Subject: **COLUMBIA GENERATING STATION, DOCKET NO. 50-397  
LICENSE AMENDMENT REQUEST -- ALTERNATIVE SOURCE TERM  
RESPONSE TO REQUEST FOR ADDITIONAL INFORMATION**

LICENSE AMENDMENT REQUEST -- ALTERNATIVE SOURCE TERM  
RESPONSE TO REQUEST FOR ADDITIONAL INFORMATION

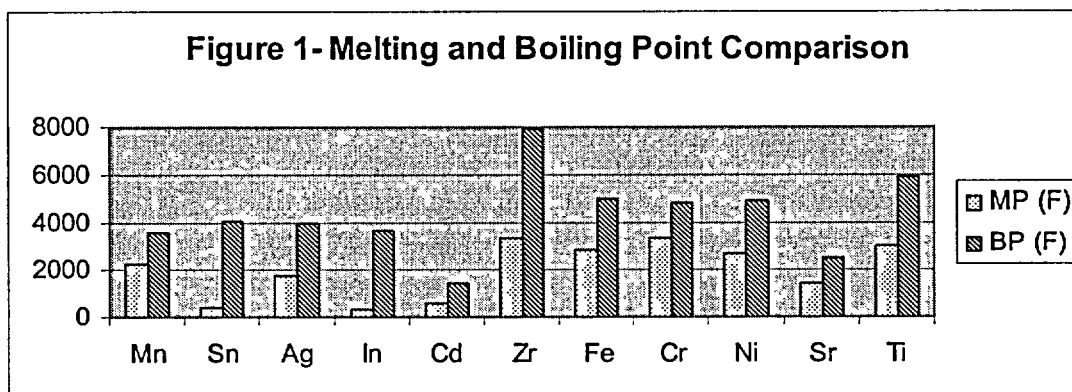
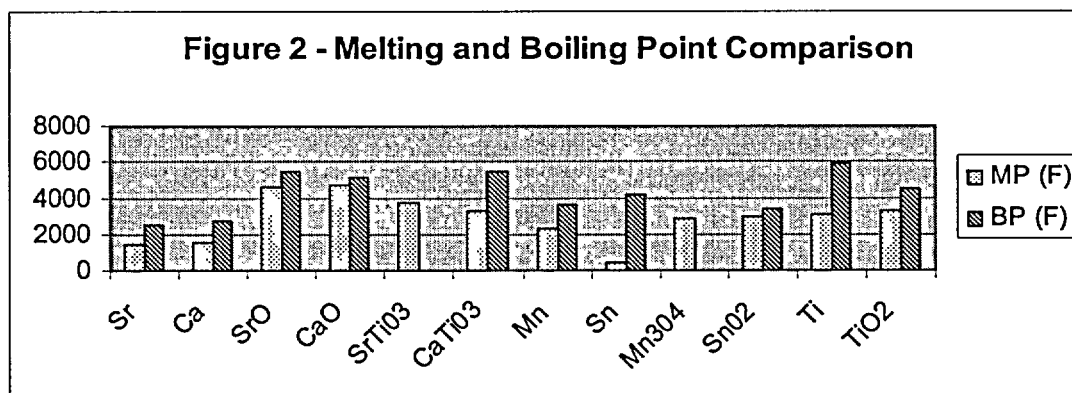
Question 9: The LOCA calculation (PSAT 206CT.QA.01.10 "onsite and control room dose calculation for Energy Northwest's Columbia Generating Station using the Alternate Source Term and RADTRAD Methodology") states that the Sr-90 (strontium) dose conversion factor used in the Columbia LOCA analysis is different from the value used in the RADTRAD code. Justify the Sr-90 dose conversion factor used by Energy Northwest. Provide proof that the isotopic Sr source is not in the form of  $SrTiO_3$ .

The potential for fission product strontium being released in the chemical form  $\text{SrTiO}_3$  is affected by two factors: (1) the availability of titanium in a core damage accident and (2) the volatility of  $\text{SrTiO}_3$  relative to that of  $\text{SrO}$ . These factors are addressed in what follows.

Titanium is a trace constituent of some austenitic stainless steels that is added to reduce susceptibility to inter-granular corrosion. It is generally less than 0.5% of the steel composition. This may be compared to other minor constituents such as manganese, which is typically two percent. Oxides of manganese and of tin (a minor constituent of zircaloy) are two of the major components of structural aerosols (along with silver, indium, and cadmium from control rods for certain plants) predicted to be released along with fission products as a result of a core damage accident. Manganese, tin, silver, indium, and cadmium are important contributors to the predicted structural aerosol release as opposed to the much more abundant zirconium, iron, chromium, and nickel, because of the relative volatility of these materials. The melting points and boiling points of manganese, tin, silver, indium and cadmium (the predicted components of core damage structural aerosols) are compared to those of the much more abundant zirconium, iron, chromium, and nickel in Figure 1 (in degrees F). Also shown are the melting and boiling points of strontium and titanium.

As indicated by a comparison of the boiling points, the volatility of strontium is greater than all of the trace alloy and control rod materials except for cadmium. Strontium, therefore, is expected to be released earlier and in relatively larger amounts than most of the volatile structural materials. Titanium, on the other hand, has a boiling point substantially greater than all of the materials shown (including all of the major structural materials that are predicted to make up only a small part of the released structural aerosol because of their low volatility) except for zirconium. Therefore, very little titanium metal is expected to be released to the gas phase.

Figure 2 shows a comparison of the available melting point and boiling point data for Sr, Ca, SrO, CaO (lime), SrTiO<sub>3</sub> and CaTiO<sub>3</sub> (perovskite). Also shown for comparison are the metallic and oxide forms of Mn, Sn, and Ti.

From Figure 2, it can be seen the metallic and oxide forms of strontium and calcium are quite comparable in terms of melting point and boiling point. The boiling point for CaTiO<sub>3</sub> is somewhat higher than that for CaO, and one would expect similar behavior for strontium. This indicates that, if anything, the fractional release of SrTiO<sub>3</sub> might actually be less than the fractional release of SrO; it would certainly be expected to be similar. Therefore, there would be no preferential release of SrTiO<sub>3</sub>.
